Norfolk Water System Subdivision Review

Subdivision Name: The Village at Norfolk

Reviewed By: Ryan J. Allgrove, P.E.

Date: May 10, 2017

PRELIMINARY CONDOMINIUM SITE PLAN
(PER M.C.L. CH. 40B)
"THE VILLAGE AT NORFOLK"
IN
NORFOLK MASSACHUSETTS

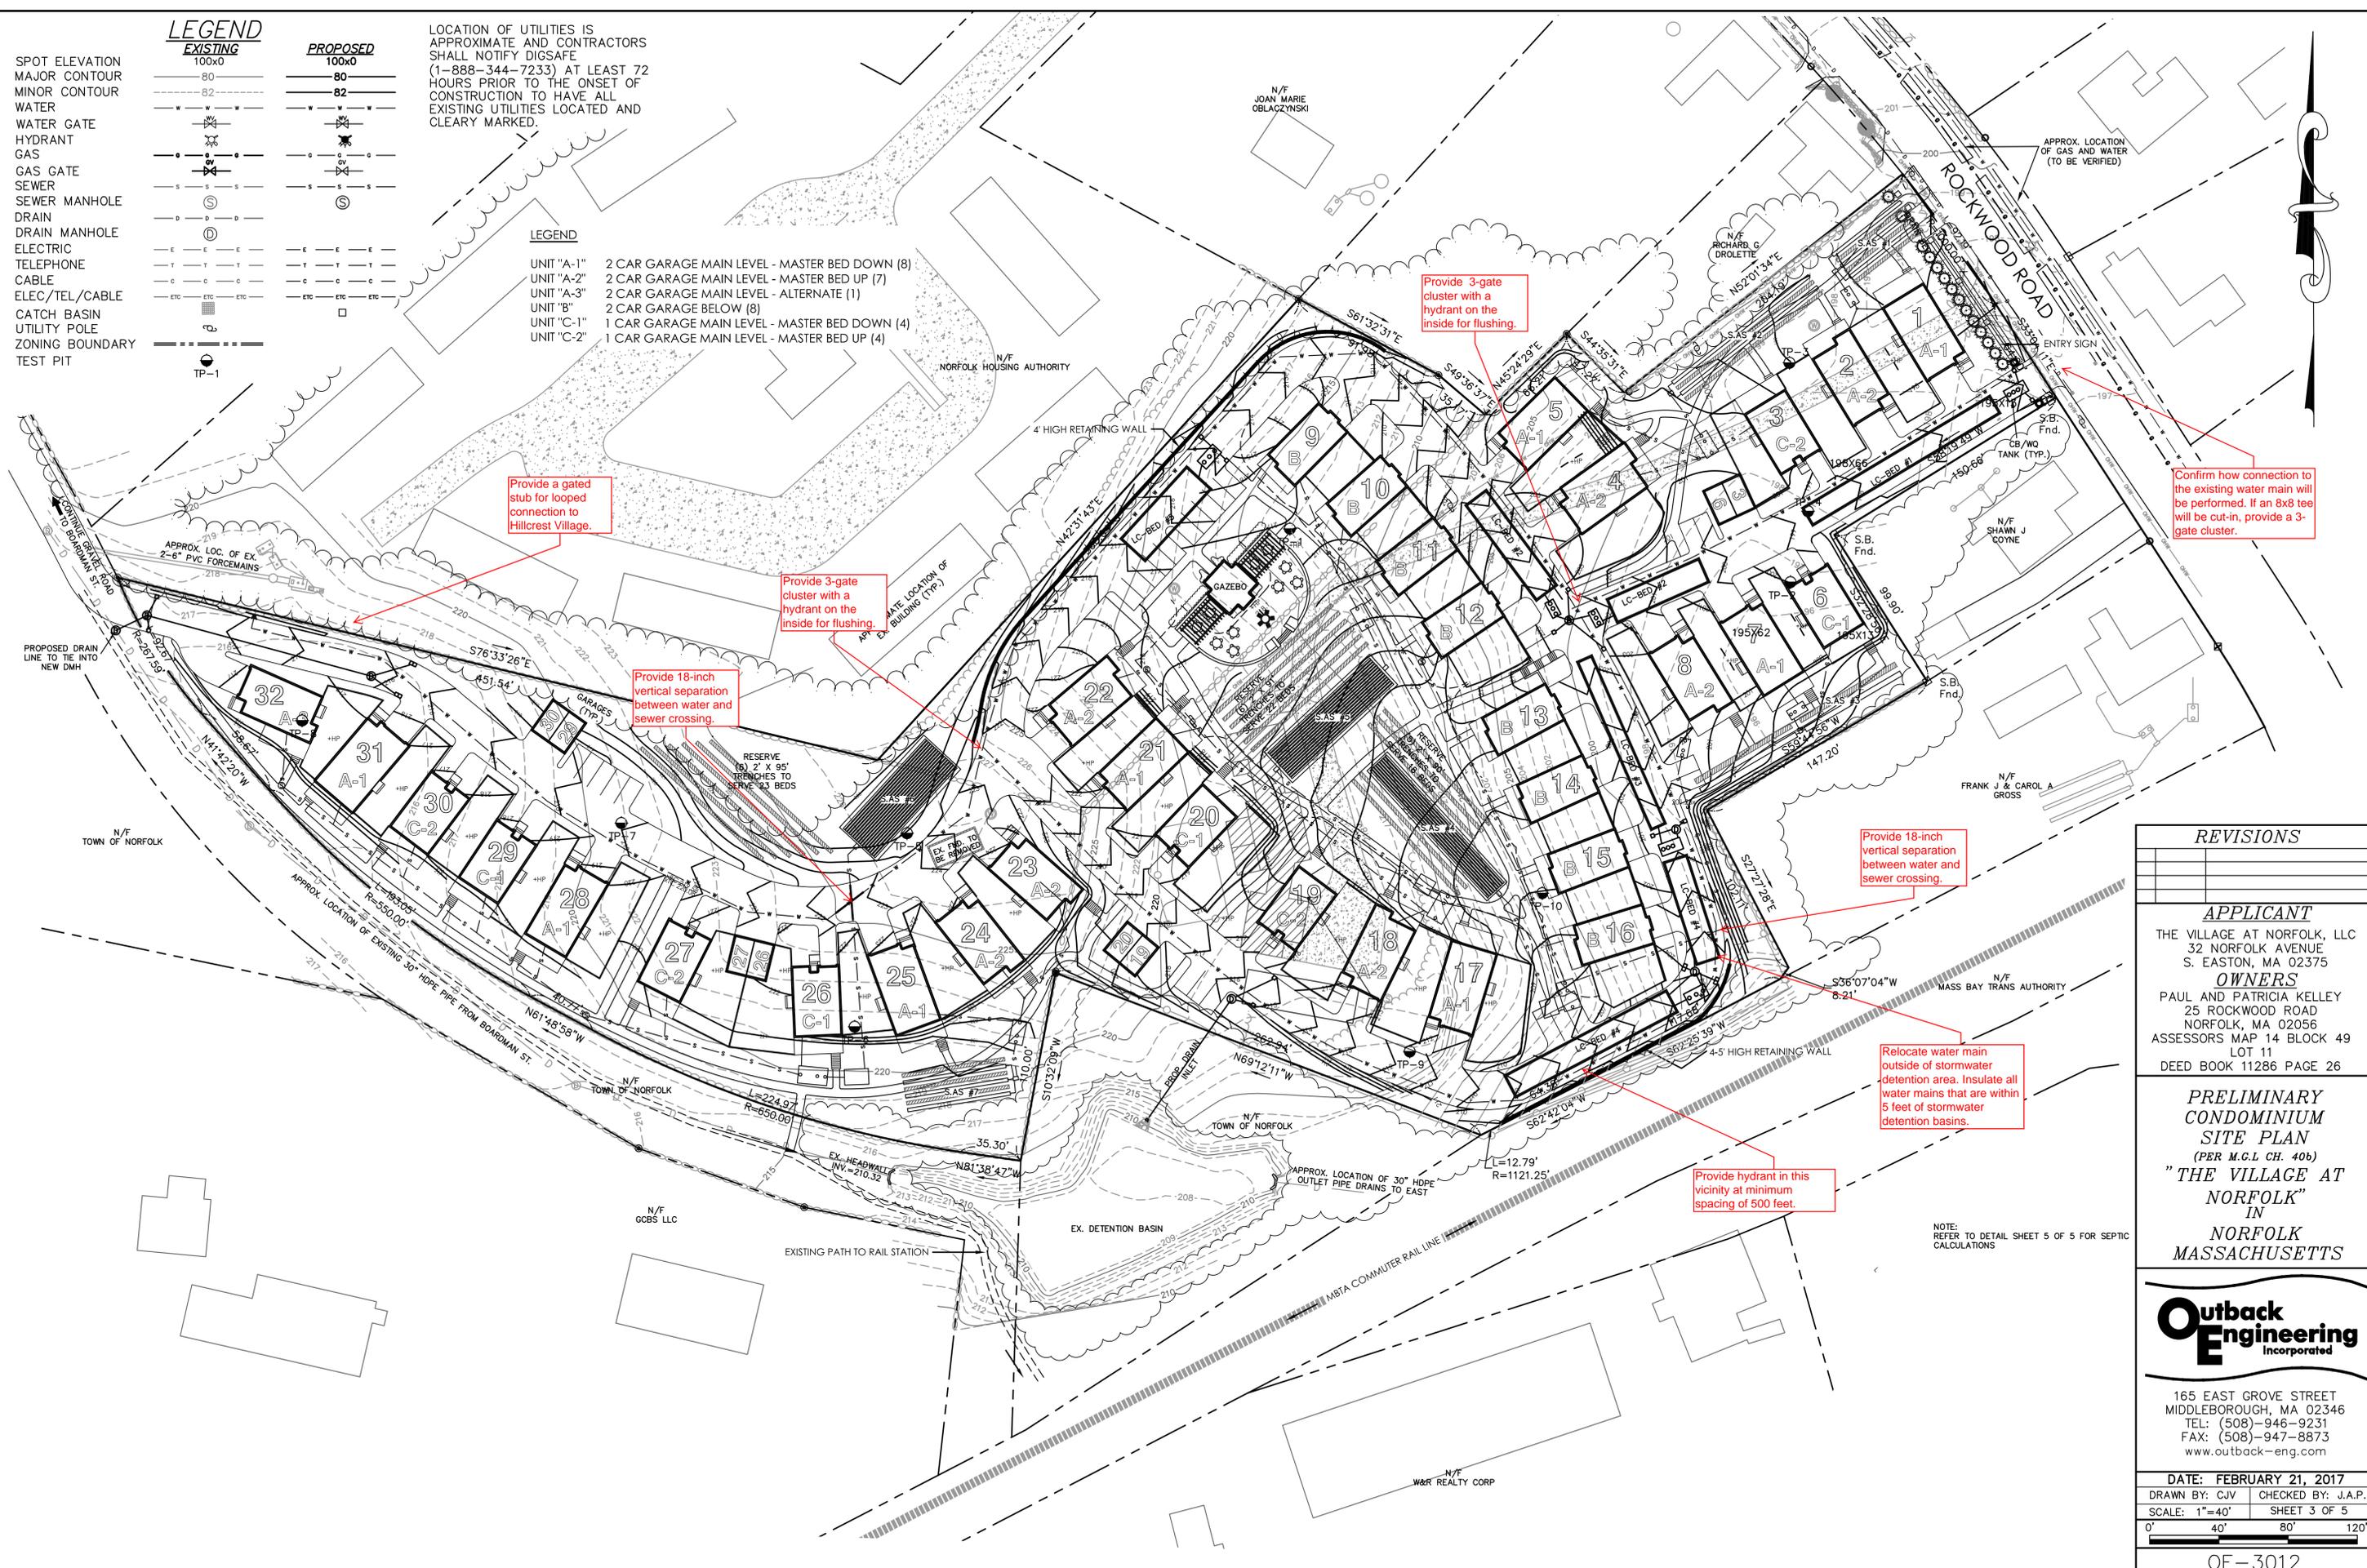
Provide a gated stub for looped connection to Hillcrest Village.

Provide 3-gate cluster with a hydrant on the inside for flushing.

Provide 18-inch vertical separation between water and sewer crossing.

Provide 3-gate cluster with a hydrant on the inside for flushing.

Provide 18-inch vertical separation between water and sewer crossing.

Relocate water main outside of stormwater detention area. Insulate all water mains that are within 5 feet of stormwater detention basins.

Provide hydrant in this vicinity at minimum spacing of 500 feet.

Confirm how connection to the existing water main will be performed. If an 8x8 tee will be cut-in, provide a 3-gate cluster.
